# SERVICE BULLETIN

SB No. 88 Issue No. 2

**TITLE** RUDDER PEDAL TO MIXTURE LEVER POTENTIAL FOUL

T67M260 and T67M260-T3A aircraft Pre Mod M687 standard.

Fig 1  
View looking forward onto No. 3  
Rudder Pedal

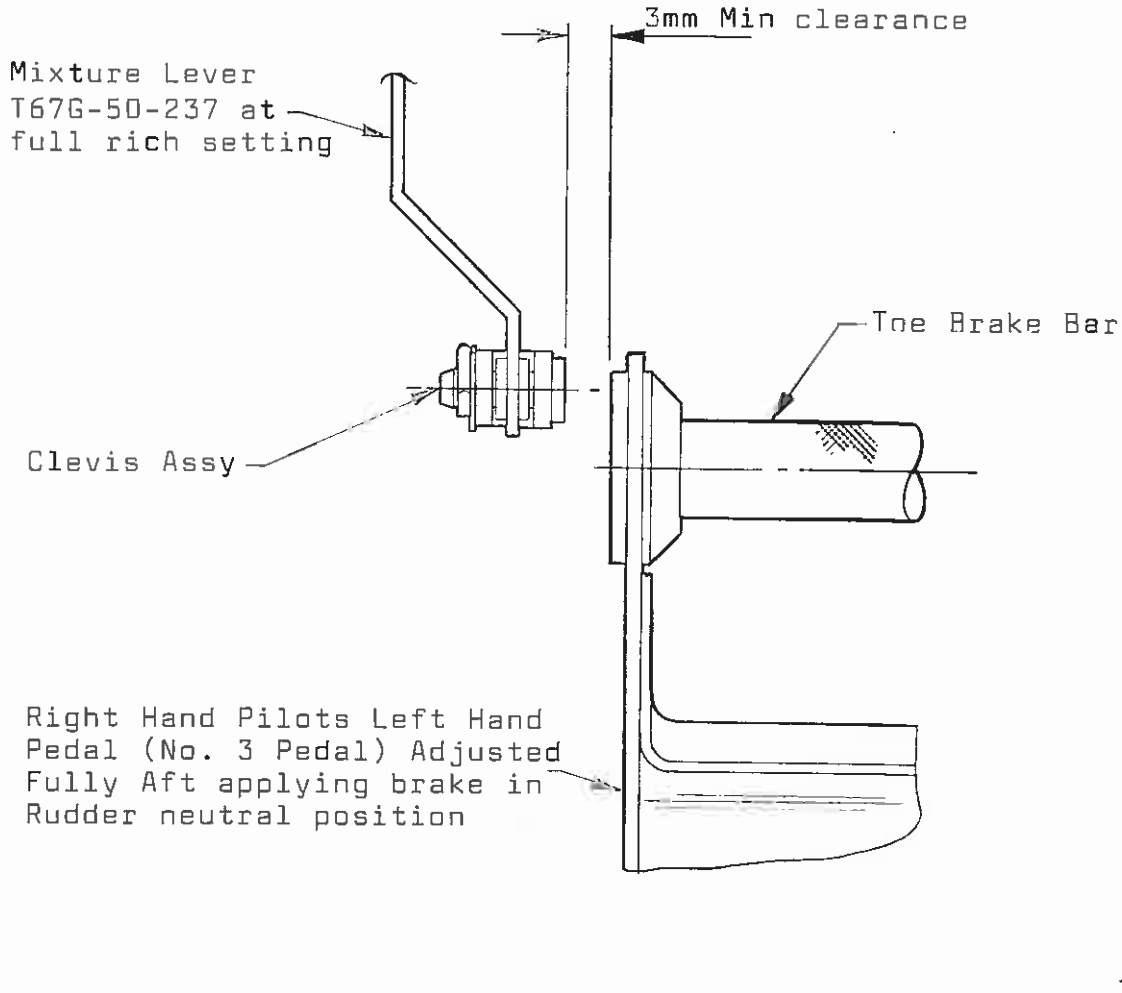
1. With mixture lever in fully rich position, adjust R.H. pilot's pedal fully aft. Then with neutral rudder applied apply full brake together with a left hand side force, sufficient to take up any free play, on the pedal side plate. Check pilots left hand pedal (pedal No.3) clearance with mixture lever. Refer to Fig. 1.

- 1.1 If there is a positive foul then invoke Mod M687A and B.
  - 1.2 If clearance is within 3mm, then flights may continue with the inspection at Action 1 repeated at each 50 hour interval until Mod M687 A and B are available.

- 1.2 If clearance of 3mm or more achieved then refer Action 3.
2. With R.H. pilots left pedal (Pedal No.3) adjusted fully forward, with left rudder applied, apply brake together with a left hand side force on the pedal. Check for clearance on mixture/prop speed cable support bracket, ref Fig. 2.

FIG 2  
VIEW LOOKING FORWARD ONTO NO. 3 RUDDER PEDAL

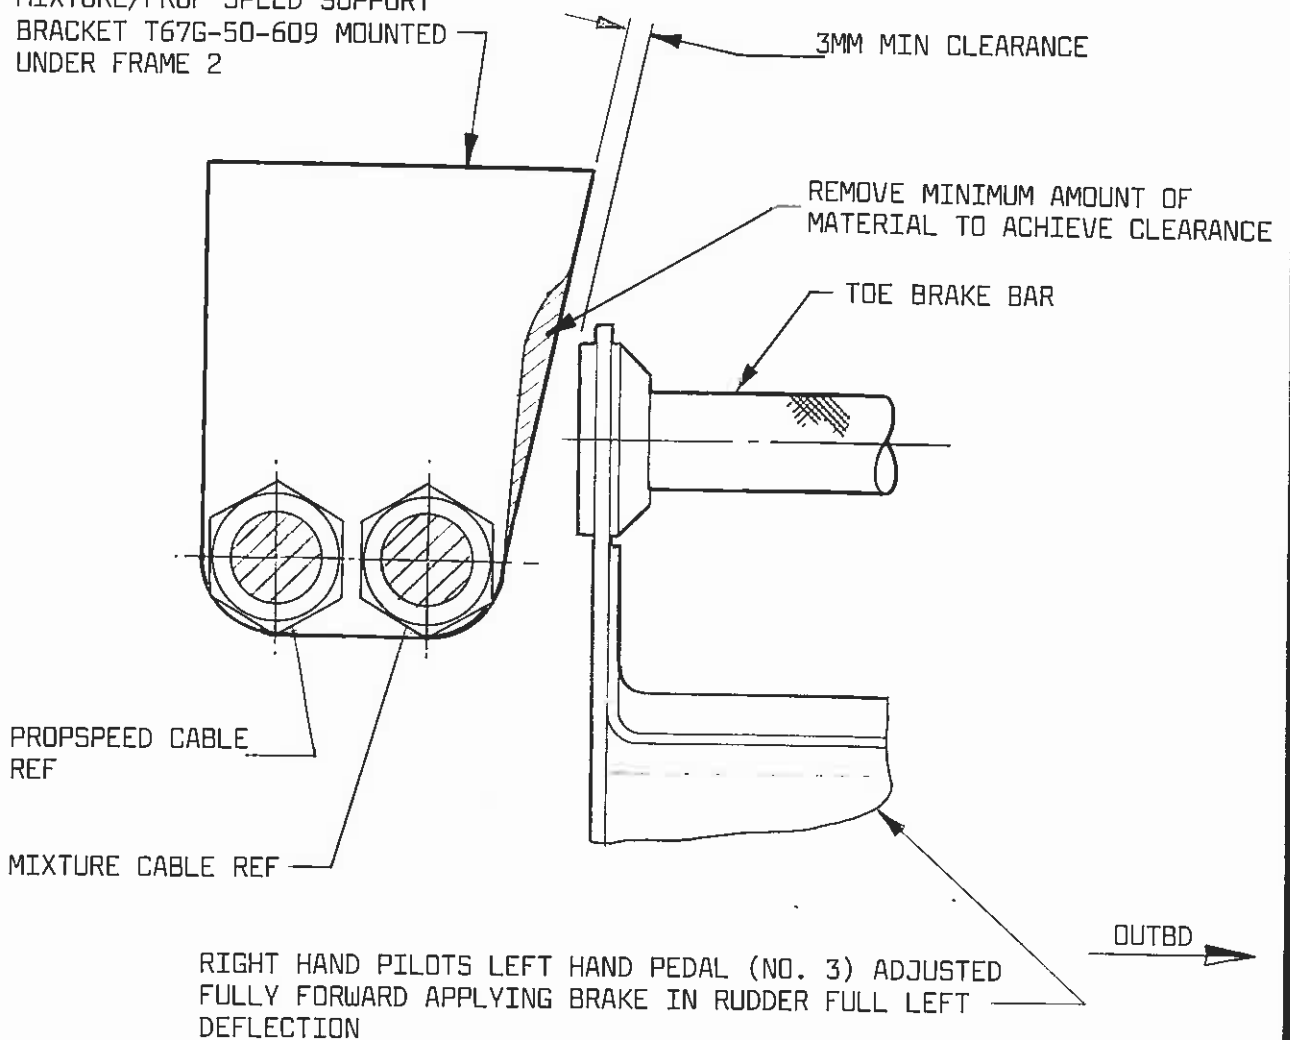
- 2.1 If there is a positive foul then either i) invoke Mod M687A and B or ii) if Mod M687A and B is unavailable, remove material from bracket ref Fig. 2 to achieve a clearance of within 3mm. Change bracket when Mod M687A and B available.

2.2 If clearance is within 3mm, then flights may continue with the inspection at Action2 repeated at each 50 hour interval until Mod M687A and B available.

2.3 If clearance of 3mm or more achieved then refer Action 3.
